Access Compliance Report

Public Rights-of-Way

Intersection ID: 10024872	Main Street: DEWITT_LN	Cross Street: N/A	Location: NE
ADA ID: 479D786AC78F	Ramp Type: PerpDiag	Initial Pass/Fail: Fail	Overall Compliance: No
Severity Score: 10			
Codes/Mitigation Info/Possible Solution		Field Measurements/Component Compliance

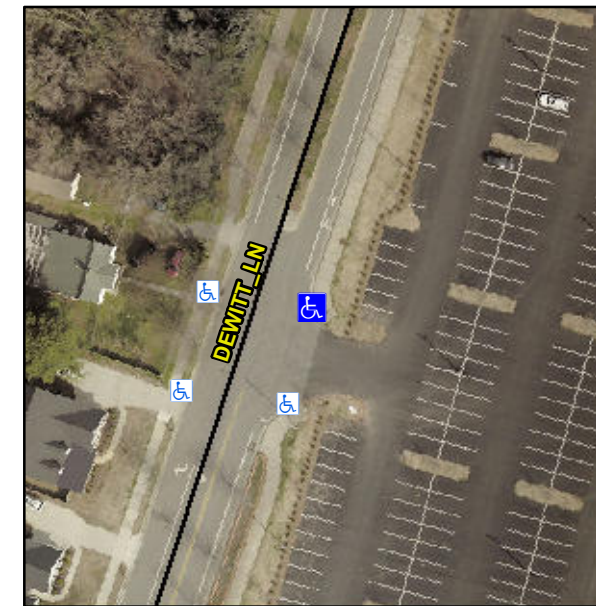
R304.5.1, R304.5.3

Compliance	Description	Data	Compliance	Description	Data
N/A	Ramp Length (in)	95.0	Yes	Ramp Slope (%)	5.4
No	Ramp Width (in)	47.0	No	Ramp XSlope (%)	3.8
N/A	Flare Type LT	N/A	N/A	Flare Type RT	N/A
N/A	Flare Slope LT (%)	N/A	N/A	Flare Slope RT (%)	N/A
N/A	Flare Traversable LT?	N/A	N/A	Flare Traversable RT?	N/A
N/A	Landing Length (in)	N/A	N/A	DWS Provided?	N/A
N/A	Landing Width (in)	N/A	N/A	DWS Contrast?	N/A
N/A	Landing Slope (%)	N/A	N/A	DWS Length (in)	N/A
N/A	Landing X Slope (%)	N/A	N/A	DWS Full Width?	N/A
N/A	Landing Curb? (Y/N)	N/A	N/A	DWS Offset (in)	N/A
N/A	Shared Landing?	N/A			
N/A	Gutter Ponding?	N/A	N/A	Gutter Slope (%)	N/A
N/A	Gutter Lip Ht (in)	N/A	N/A	Gutter X Slope (%)	N/A
N/A	Painted X Walk1?	No	N/A	Painted X Walk2?	No
	X Walk 1 Direction	To NW		X Walk 2 Direction	To SW
N/A	X Walk 1 Width (in)	N/A	N/A	X Walk 2 Width (in)	N/A
	X Walk 1 Slope (%)	4.7		X Walk 2 Slope (%)	1.1
	X Walk 1 X Slope (%)	2.8		X Walk 2 X Slope (%)	6.6

Remove & Replace Curb Ramp With Two New Directional Ramps or Equivalent.
